DOCKET												
10-E	10-BSTD-01											
DATE												
RECD.	Oct. 31 2011

# Docket number 10-BSTD-01, Oct. 13<sup>th</sup>, 14<sup>th</sup> 2011 Workshop Comments to the California Energy Commission by Mike Gabel on the Initial Draft Language of the 2013 Standards

#### TABLES 140.3-A and B: Fenestration Values

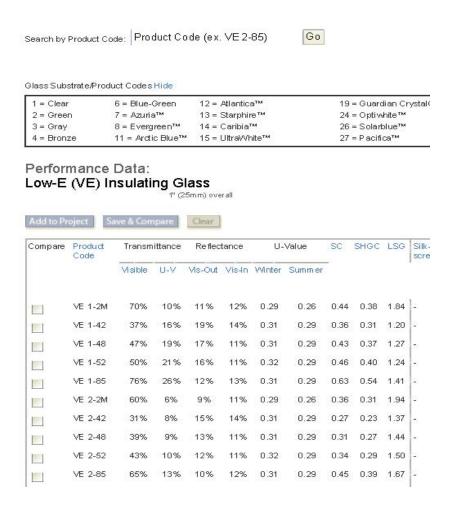
As Gary Farber has correctly pointed out, "Windows" should be listed as "Vertical Glazing".

My research shows that the category called "Glazed Doors" is too broad, and should be subdivided into "Swinging Doors" and "Sliding Doors". I cannot find any metal thermally broken sliding doors that meet the listed U-factor of 0.45, but only a value of 0.51. Is it the intention of the Commission to disallow any kind of metal sliding doors from using a prescriptive approach? If so, then the table is okay. Otherwise, for new construction:

- U-factors seem achievable with the best metal thermally broken frames.
- SHGC ("Max RSHG") values <u>are barely achievable</u> with a <u>very limited percentage</u> of the best metal thermally broken frames, based on the research I've done on the NFRC web site and looking at manufacturers' data such as that by Kawneer. More plausible prescriptive SHGC values would be to set the value to 0.27 for all these

categories, which implies a COG value of 0.27 (i.e., triple silver low-e visually clear with a high VT) and any thermally broken metal frame that does not degrade the COG value. Even this relatively minor adjustment will result in enormously better fenestration performance than current standards as the following graphics – based on the CEC draft values – illustrate (see Appendix to Gabel Comments).
